Access Compliance Report

Public Rights-of-Way

Intersection ID: 10748	Main Street: JOHNSON_ST	Cross Street: POLK_ST	Location: E
ADA ID: DF351817CECA	Ramp Type: Directional1	Initial Pass/Fail: Fail	Overall Compliance: No
Severity Score: 22.5			
Codes/Mitigation Info/Possible Solution		Field Measurements/Component Compliance

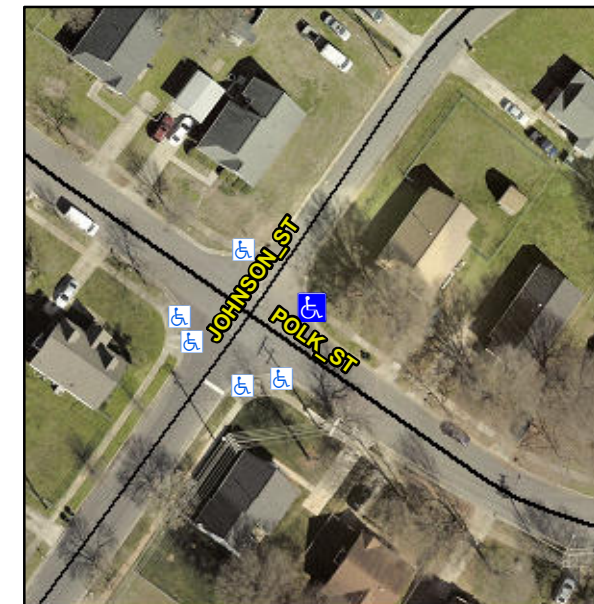
VEGETATION OVERGROWTH

R304.5.1, R304.2.2, R304.5.3

Remove & Replace Entire Ramp.
